**LEVY NUCLEAR PLANT, UNITS 1 AND 2
DOCKET NOS. 52-029 AND 52-030**

**REVISION TO RESPONSE TO REQUEST FOR ADDITIONAL INFORMATION LETTER NO. 087
RELATED TO SEISMIC DESIGN PARAMETERS**

**Levy Nuclear Plant Units 1 and 2
Response to NRC Request for Additional Information Letter No. 087 Related to
SRP Section 3.7.1 for the Combined License Application, dated March 17, 2010**

NRC RAI NUMBER: 03.07.01-02

Figure RAI 03.07.01-02-1 Rev 0

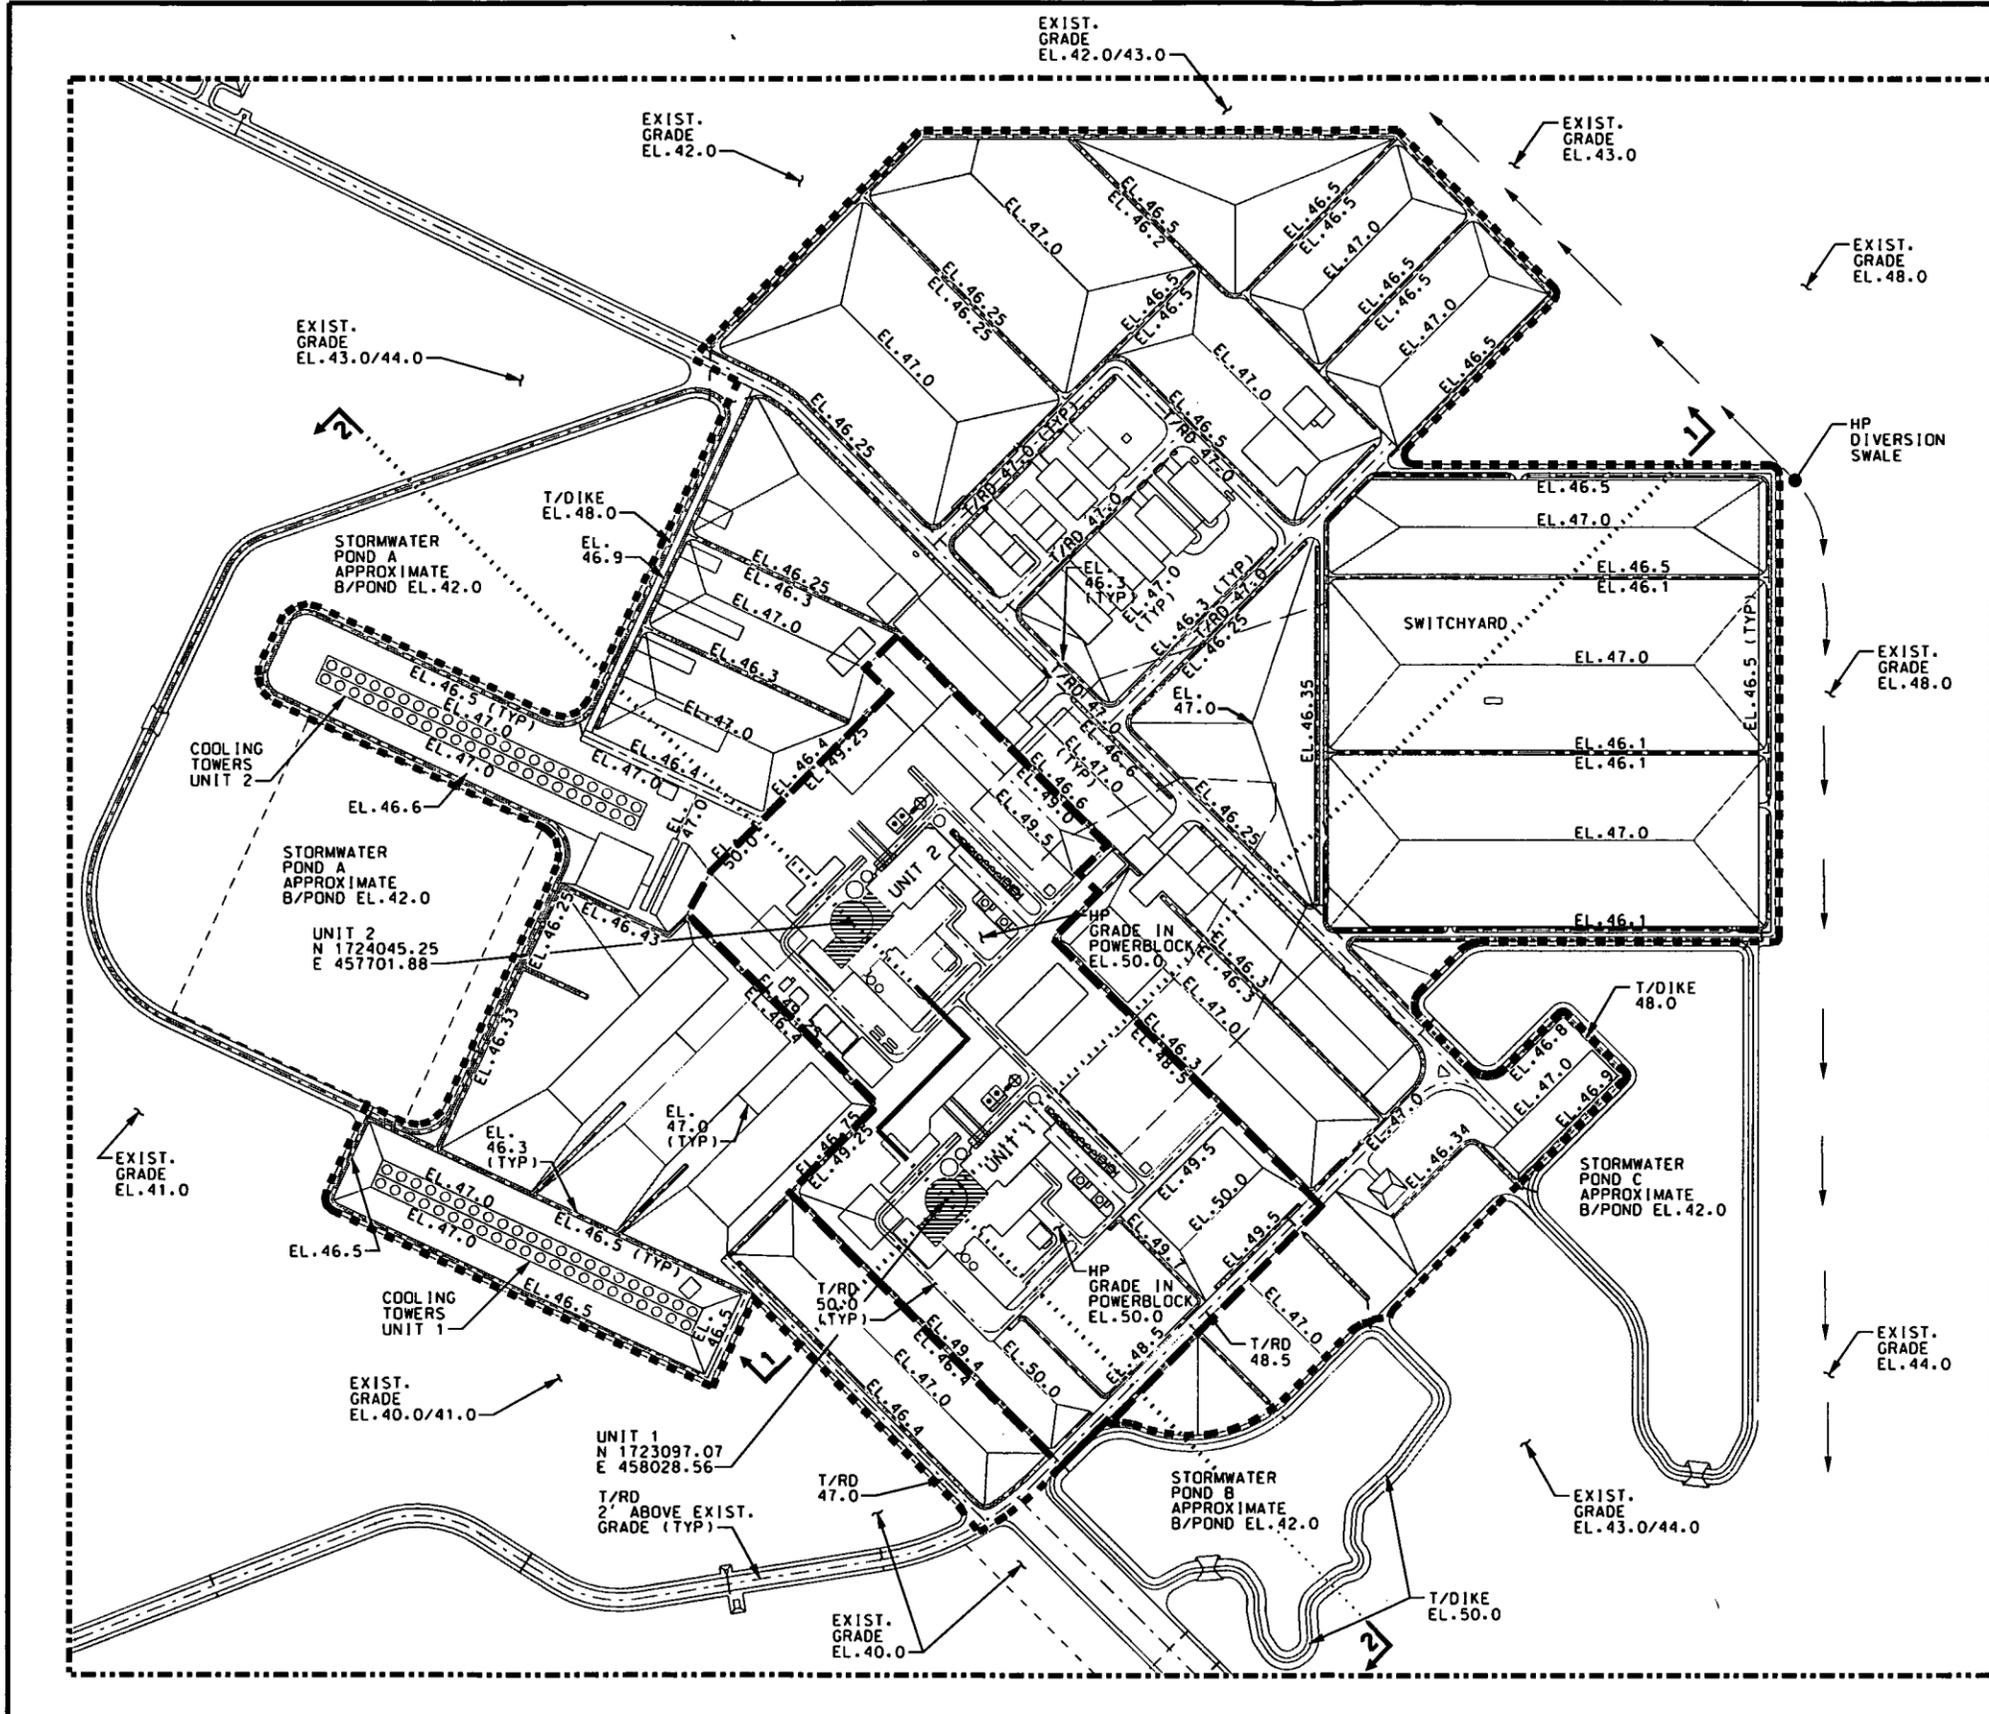
In the applicant's response to Question 03.07.01-1 of RAI 2318 (NRC Letter No. 046), the applicant describes the approach used to develop revised site specific seismic ground motions (response spectra). These analyses include engineered fill as part of the soil columns used to develop the ground surface spectra. However, it is not clear from the discussion what the extent of the changes to the site (excavation and placement of engineered fill) are planned and if these changes are to such an extent as to affect the seismic ground motion. Thus, the staff is requesting the applicant to provide information regarding the extent of planned excavation and placement of engineered backfill and an assessment of whether these changes are sufficiently extensive such that the surface ground motion would be modified. Additionally, please provide a discussion that summarizes the planned construction sequence of removal of near surface soils, placement of engineered fill, drilled shaft installation for adjacent structures, construction of the diaphragm wall, and excavation of soil material beneath the NI structures as it relates to potentially changing the ground motion as is inferred by incorporating the engineered fill in the SSI soil columns.

Figures RAI 03.07.01-02-1 and RAI 03.07.01-02-2 show the conceptual grading plan and the conceptual grading section for the LNP site respectively. The plant Nuclear Island (NI) footprint (approximately 0.8 acres for each unit) is small compared to the approximately 347 acres where fill will be placed to raise the existing grade level. The existing grade in the plant footprint area is at approximate elevation 12.8 m (42 ft.) NAVD88. The finished grade in the 347 acre fill area will vary from elevation 15.2 m (50 ft.) NAVD88 to elevation 14.3 m (47 ft.) NAVD88. The grading is designed to prevent flooding of the work area during construction and plant operation.

Figures RAI 03.07.01-02-1 and RAI 03.07.01-02-2 show the conceptual grading plan and the conceptual grading section for the LNP site respectively. The plant Nuclear Island (NI) footprint (approximately 0.8 acres for each unit) is small compared to the approximately 347 acres where fill will be placed to raise the existing grade level. The existing grade in the plant footprint area is at approximate elevation 12.8 m (42 ft.) NAVD88. The finished grade in the 347 acre fill area will vary from elevation 15.2 m (50 ft.) NAVD88 to elevation 14.3 m (47 ft.) NAVD88. The large extent of the fill area compared to the NI footprint and because the PBSRS is higher than the GMRS for the LNP site, inclusion of the fill to design grade for the free field response analysis and the SSI analysis is appropriate.
